**Scarborough
Light
Rail Transit
Kennedy Station
to Town Centre**

SCARBOROUGH LRT REDUX
SRT ISSUES AND OPTIONS

MARCH 9, 2010

TTC 2009 Proposal

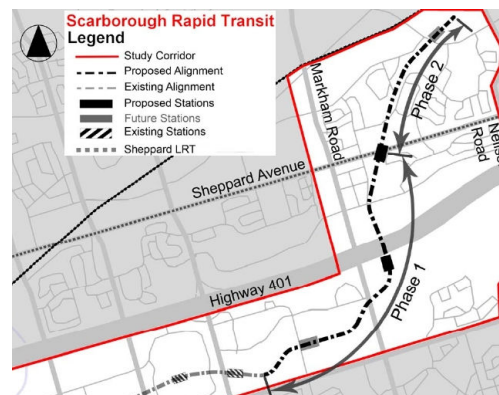
The TTC has not revisited the work done to date that never considered converting the existing line from Kennedy to McCowan from the existing technology (ICTS) to LRT like the rest of Transit City. This is evident by the fact that the defining characteristics of the alignment are identical to the proposed alignment for an ICTS-compatible implementation in 2009. This is a significant oversight when the public feedback collected from the past public consultations is analyzed objectively.

Alignment Comparison Comments from TTC 2009 Presentation Boards

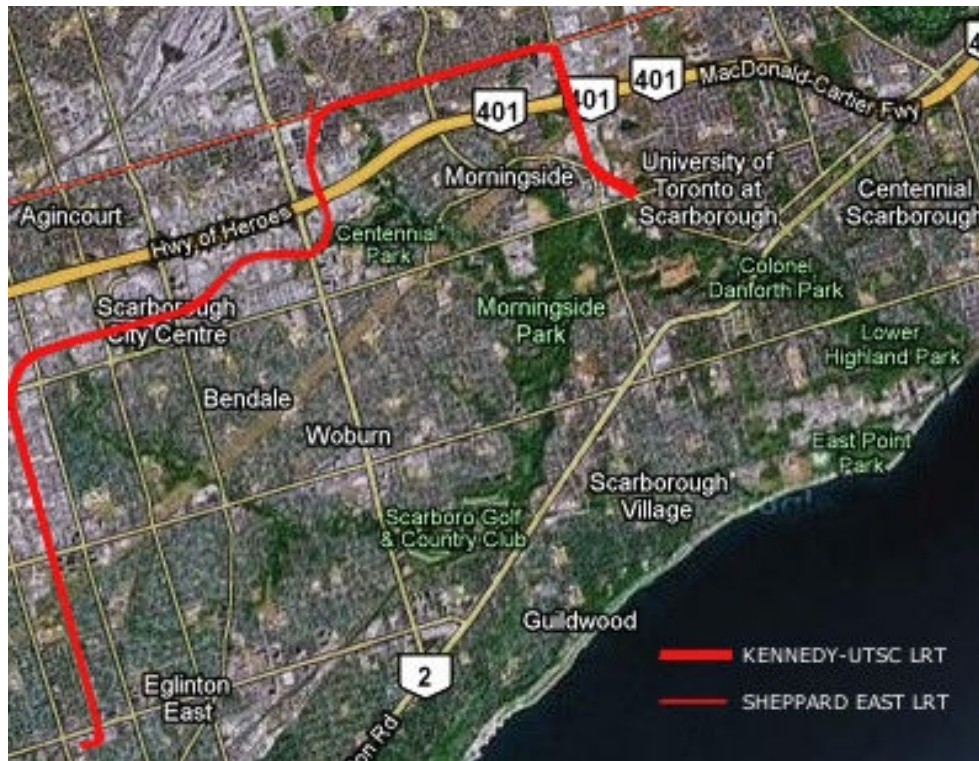
What is curious now is that the TTC is proposing alignment "S3," which had the poorest ranking of all the options west of Centennial College. If it scored so poorly, why is it now being selected? "S3" scored the worst for pedestrian access to developments, worst for coverage, worst for supporting the secondary plan, worst for spurring transit-oriented development, and worst for environmental (but not community) impacts. As a line that would be elevated east from Bellamy Rd, it would also be more expensive to construct than an at-grade version of alignment "S1."

The Bellamy Station and relocated McCowan Station of alignment S1 provide the shortest walking distance to existing higher density development in the area. Walking distances are slightly longer with alignments S2 and S2 modified and the longest for alignment S3.

The proposed Bellamy Station and relocated McCowan Station of alignment S1 provides the best overall coverage within the Scarborough City Centre Secondary Plan area, and thereby provide the greatest support for City planning objectives and transit oriented development opportunities. S2 and S2 modified alignments can provide most of these benefits. S3, which pushes Bellamy Station further south, provides the least support of the alternative being considered.

S2 modified is the most preferred as it has the lowest impacts to the businesses along Progress Avenue and modest adverse effects to the natural environment. Although S3 has the potential to greatly impact Highland Creek, these impacts can be mitigated whereas the impacts to businesses along Progress (associated with S1) cannot be readily mitigated and therefore S1 is least preferred.

Capacity Impacts of ATO

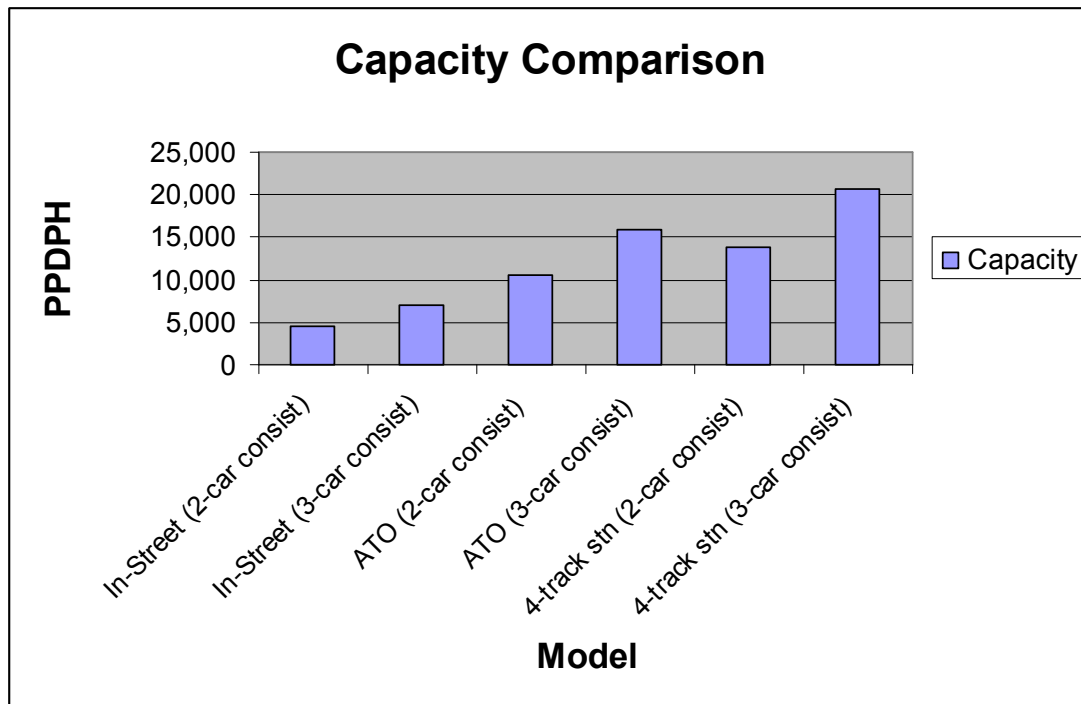
The TTC seeks ATO to be implemented on the SRT (both the existing line and the extension) to prepare for a projected 2031 peak demand of 10,000ppdph entering Kennedy Station. Staff say that they will not be able to meet the 2031 demand projections for the line without ATO as the headways will not be able to reliably keep up. This is true in the context of a strictly 2-track line continuously from end to end, and in that context ATO makes sense. However, this is not the only approach, and is not necessarily the best approach either.

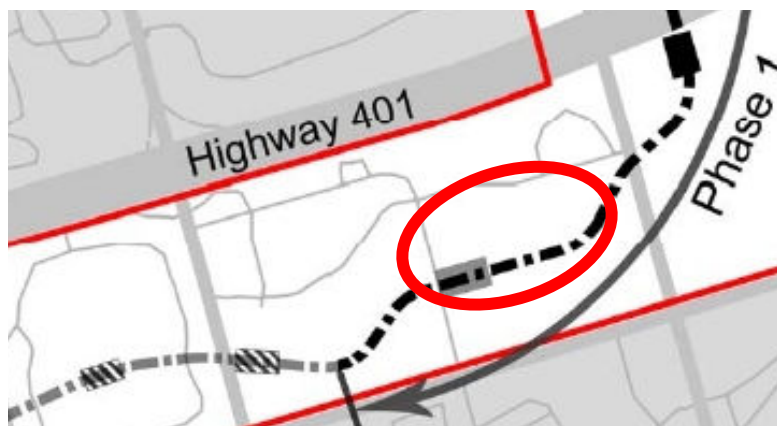
The staff argument of “avoiding parklands as much as possible” is not to be achieved at any cost, evident by the York University Busway running through parklands, and by the staff proposal for consuming the parklands in the southeast quadrant of the McLevin Ave and Tapscott Rd intersection with an elevated station, commuter parking, and a bus terminal; if parklands are that important, why not leave the line underground in Malvern? The TTC should at least be consistent.

The “park” above the proposed tunnel is in fact a preserved railway corridor: Preserved for the SRT rail line. This land has been reserved for the SRT for a long time, and there is no reasonable justification to tunnel beneath it given the other options available at substantially less cost while still meeting the needs of the communities as well as the needs of the SRT extension itself.

TTC Proposed SRT Alignment By Future Bellamy Yard Site (Circled in Red)

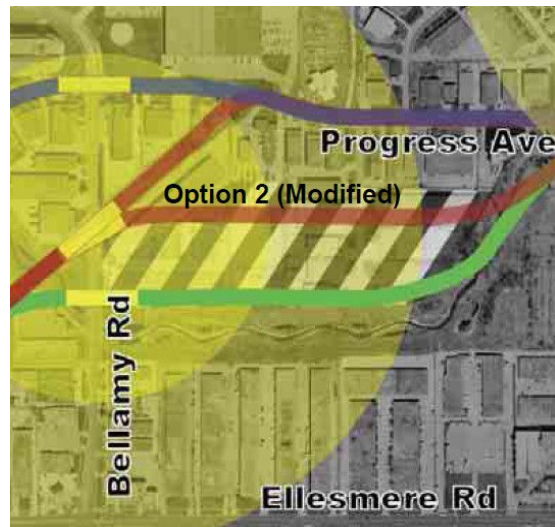
The TTC wishes to continue to protect the site of a Bellamy Yard for possible future fleet growth beyond 2031. This is prudent; however, it does not make sense for a potential future yard site to dictate the alignment of the SRT extension, as appears to be taking place.

The TTC can continue to hold on to the property of the current eastern tail of the SRT east of McCowan Station even if it is not being used for anything. Assuming alignment “S1” were to go forward, as City Planning and the Scarborough Centre Secondary Plan would prefer, the lands of the existing east tail of the SRT could then be used as one of two access points to a future Bellamy Yard, with another coming down Bellamy from Progress, or – alternatively – coming in off the southwest quadrant of the Markham Rd and Progress Ave intersection. There is no need for the alignment to run immediately alongside a yard that isn’t going to be used for a couple of decades (if at all), particularly when such an alignment results in the worst evaluation scores, as appears to be the case with the SRT extension.

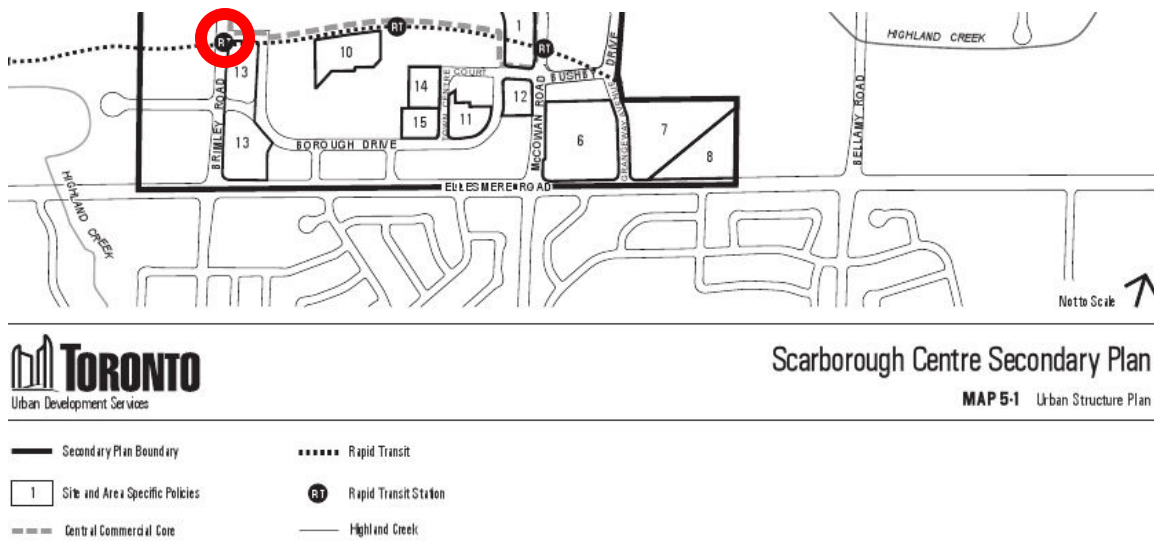
The TTC still is not committing to the construction of a Brimley Station between Midland and Scarborough Centre stations, despite the position of City Planning and Transportation Services at the City of Toronto and the position of Scarborough Community Council, both of which have made their position clear since 2006. Logically, the best time to construct such a station is while the line is down for construction anyway. The TTC is requesting building permits being presented to them prior to making any commitment to construction of a station at Brimley Rd, a break from past recent practice, such as that of the TYSSE. Brimley Station is included on the City of Toronto Urban Development Services Scarborough Centre Secondary Plan Map 5-1: Urban Structure Plan, shown below. The Secondary Plan's Brimley Station is circled in red.

Colour-Coded Diagram of Alternative Through the Markham/Progress Area

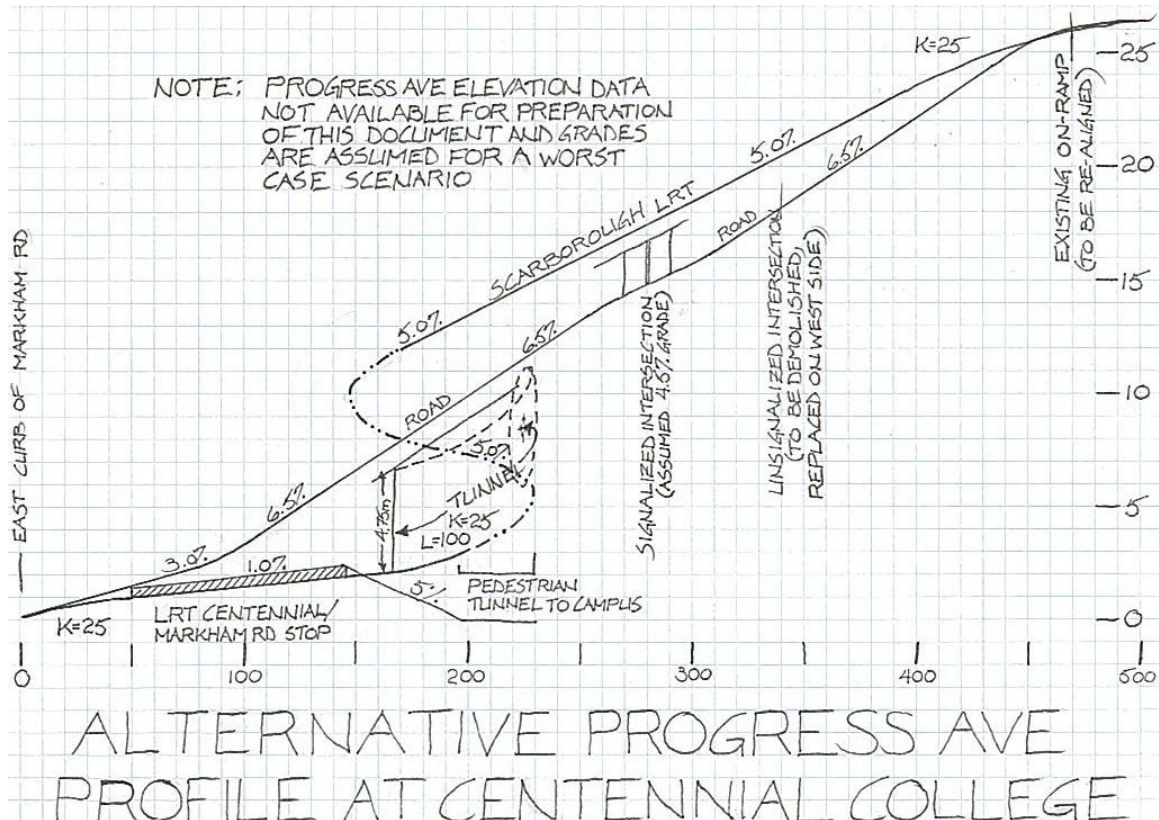
There continues to be no stop at Markham Rd, and the TTC-proposed station at Centennial College is located too far from Markham Rd to be considered servicing both locations at the same time.

Progress Ave between Markham Rd and the Highway 401 on-ramp is extremely challenging, as most of the road is very steep, at a 6.5% grade, well exceeding the LRT maximum grade of 5.0%. The rise from Markham Rd to the Highway 401 on-ramp is estimated at around 24m over a 375m climb consistently at 6.5%, which likely exceeds the real conditions for which detailed data is not available for this document. At a grade of 5.0% over the same length, the difference in height would be around 5.5m. For the LRT to rise to the same height, it would need an additional 110m or so. Challenging as the site may be, unconventional approaches can turn it into an opportunity.

If the location for a stop was at the segment of straight road on Progress Ave immediately east of Markham Rd, which is about 100m long, then both the Centennial College campus and Markham Rd would be served by a single LRT stop. Assuming a near-flat grade for the stop, part of it would be at-grade while part would have the road rise around it. The northeast-bound lanes of Progress Ave would have to be realigned at this location to accommodate the platform area(s), but no buildings exist on the south side, and this part of the Progress Ave Corridor is unusually wide.

the solution. Past the east end of the stop, the northeast-bound lanes of Progress Ave can pass overtop the LRT, and the LRT alignment can swing south of Progress Ave and do a 340-or-so degree curve with a radius of around 30m and a length of around 190m, at a grade of 5.0%. At the point where the LRT runs almost full-circle, along the east side of the road, the LRT should be about 4m higher, with 300m to the 401 to go. The difference over 300m between a rise at 6.5% and 5.0% is 4.5m, and Progress Ave becomes gentler momentarily at the traffic signal to the campus, which would see the LRT meet Progress Ave at the same elevation at the top by Highway 401.

The platform height relative to the road surface at the east end of the stop creates opportunities for grade-separated and sheltered access for pedestrians to the campus building(s) from the LRT, shown in purple in the image on the previous page, but needs to be designed carefully to maximize safety and security (good sightlines, good lighting, good acoustics, etc.).

Conceptual Road Reconfiguration for Centennial College and 401 Access

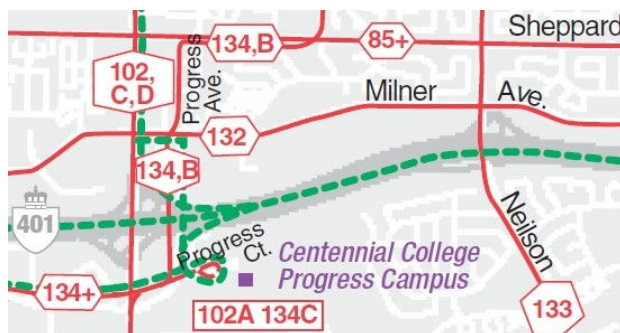
An advantage with this option is the alignment switches to the east side of Progress Ave, which is beneficial north of Highway 401. However, south of Highway 401, it causes some complications for road access to the Centennial College campus. Because the LRT will be elevated, but would not be high enough for all types of vehicles to pass beneath it at the signalized intersection, at a height clearance estimated at about 2m, reconfigured road access to the campus would be required, a potential option for which is shown below. The non-signalized road access to the campus would

have to be closed, as no vehicles would fit beneath the LRT at that point. Access to the 401 would require reconfiguration as well, as the existing ramp would be cut off by the LRT.

Conceptual At-Grade Milner Ave LRT Stop on Progress Ave

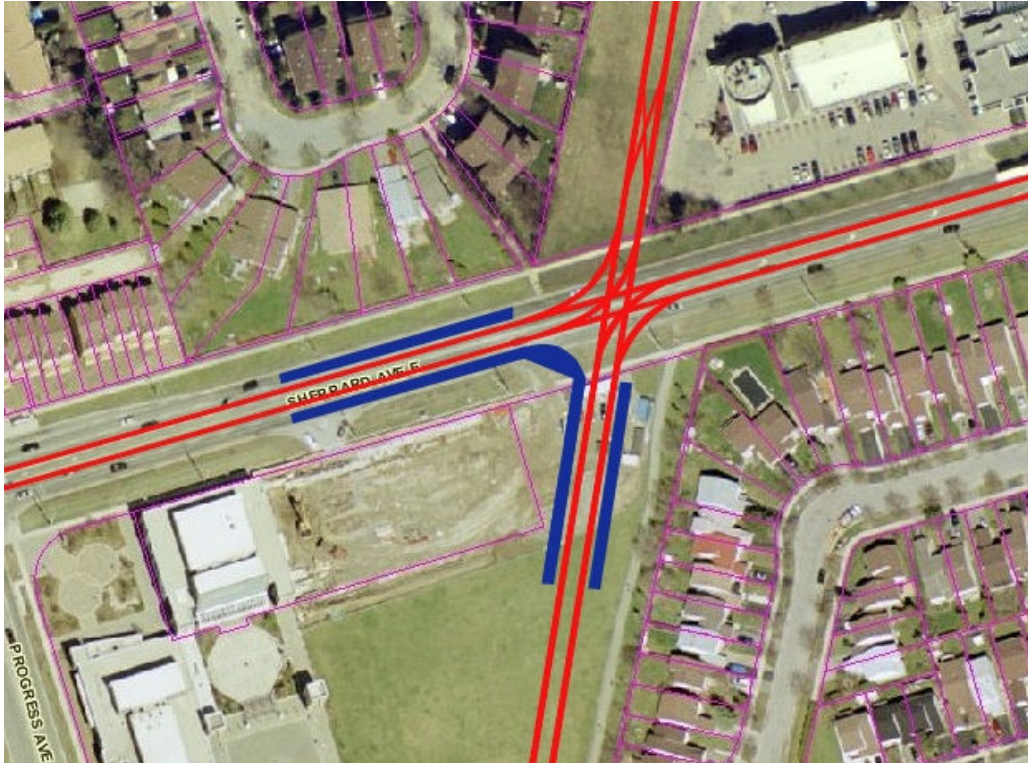
With the portal and associated grades removed from the alignment, a stop at the intersection of Milner Ave and Progress Ave can be added to the alignment to connect with the 132 Milner bus service and serve the businesses in the Milner Ave and Markham Rd area. The TTC had already planned to run the alignment on the east side of Progress Ave in this area, and the measures taken to accommodate that are assumed to be unchanged for the alternative proposed in this document, but with the LRT running at-grade and adding a stop at Milner, an example of which is shown below.

Conceptual Alternative Track and Platform Layout with North-to-East and West-to-South Curves

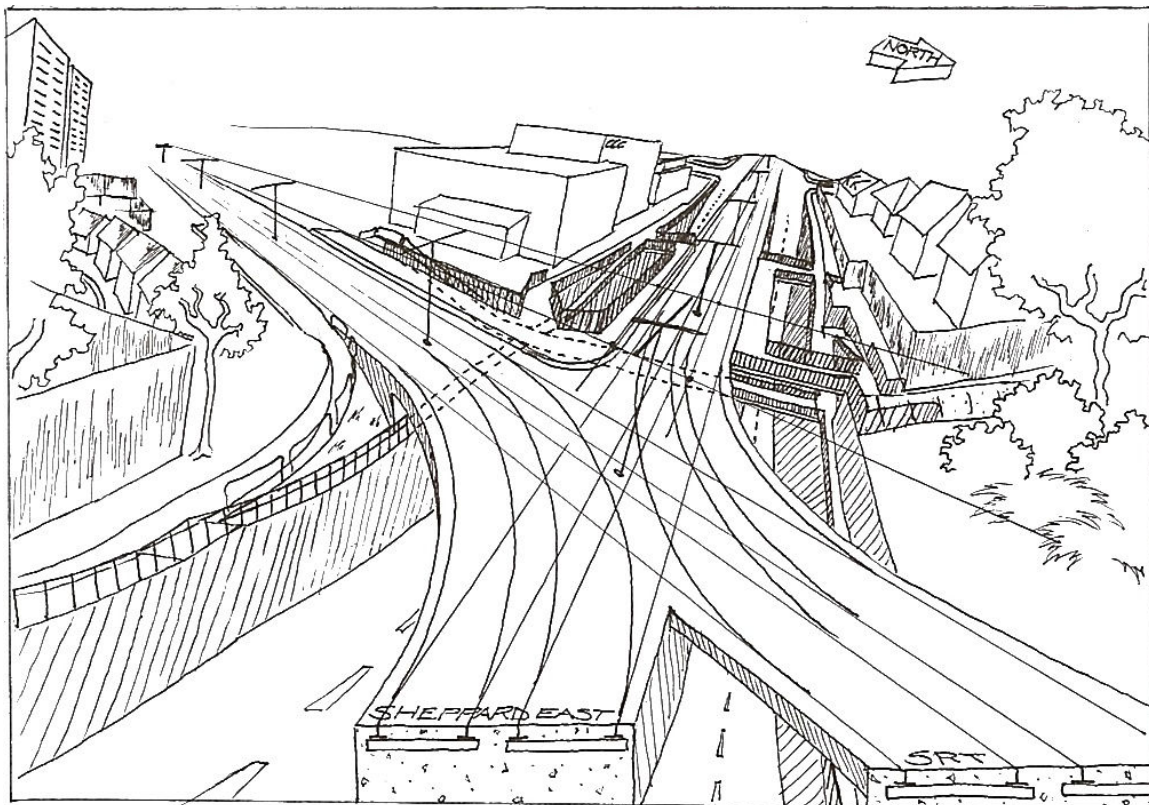
The junction proposed by the TTC between the SRT and the Sheppard East LRT is poor value. The TTC is proposing west-to-north/south-to-east single-track curve between the two lines. Of all 4 quadrants, the northeast quadrant is likely the most useless. The junction should be composed of north-to-east and west-to-south curves, which would make for gentler curves since the two lines do not intersect at right angles. East-to-north and south-to-west tracks can also be provided to short-turn Sheppard East LRVs as necessary to accommodate the SRT's interlining in the interim.

This junction should not be underground, and should not be composed of single-track curves. It makes no sense to invest the money for a portal along Sheppard to connect to the SRT purely for carhouse movements. This is a very inefficient and wasteful use of scarce capital taxpayer dollars. However, this doesn't necessarily mean that Sheppard's road traffic should not be grade-separated. It is worth noting that there are only two properties connecting to Sheppard between Progress Ave/Malvern St and Gateforth Dr. Both of these have already been proposed for expropriation by the TTC's current proposal, it should be noted. One is a parking lot for the Chinese Cultural Centre, which would have to be expropriated to run the SRT extension at grade. The other is a strip mall, which can remain if the SRT extension runs at grade and eliminates the need for an expensive interim 7-route bus terminal. Although it would not require expropriation, it would require having its access off Sheppard Ave E shifted slightly east if road traffic is grade-separated from the LRT traffic. There is an access to the strip mall's parking area off of Gateforth Dr. that would remain unaffected throughout the construction period.

3-D SKETCH OF SRT/SHEPPARD EAST LRT
ALTERNATIVE JUNCTION
N.T.S.

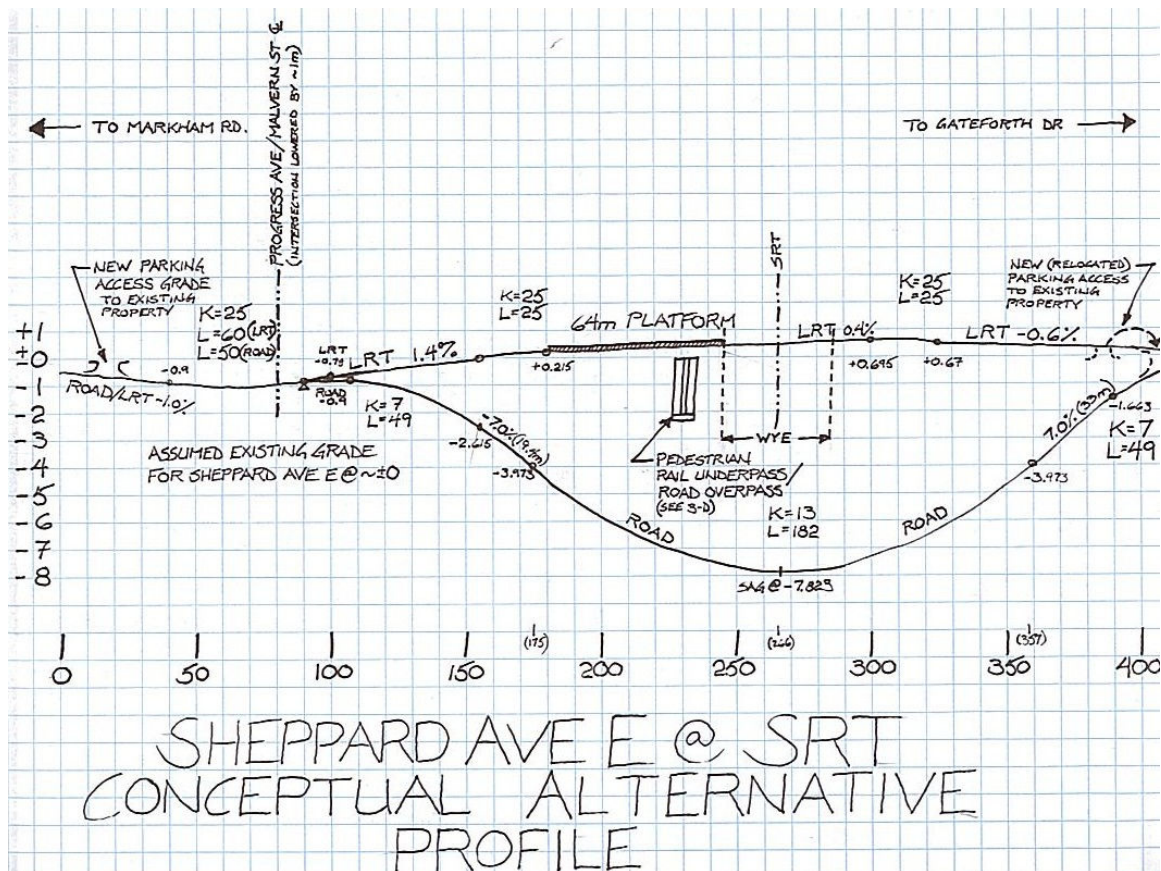
As illustrated in the images above and on the preceding page, if a slope begins along Sheppard Ave E a little west of Progress Ave/Malvern St, and includes re-grading small parts of Malvern St and Progress Ave while avoiding property impacts, Sheppard Ave E's road surface will be deep enough to have both the SRT pass overtop it, and have 60m platforms for the Sheppard East LRT above the road traffic west of the junction with the SRT. This would be a substantially less-expensive way to connect the two services, as mechanical vertical transportation is eliminated, the need for a closed fare-paid area is eliminated, and even the need for a bus terminal is eliminated, because the interim arrangement can have the SRT interline with the Sheppard East LRT to Meadowvale to connect with the various bus routes through the Malvern area. This avoids very expensive temporary facilities.
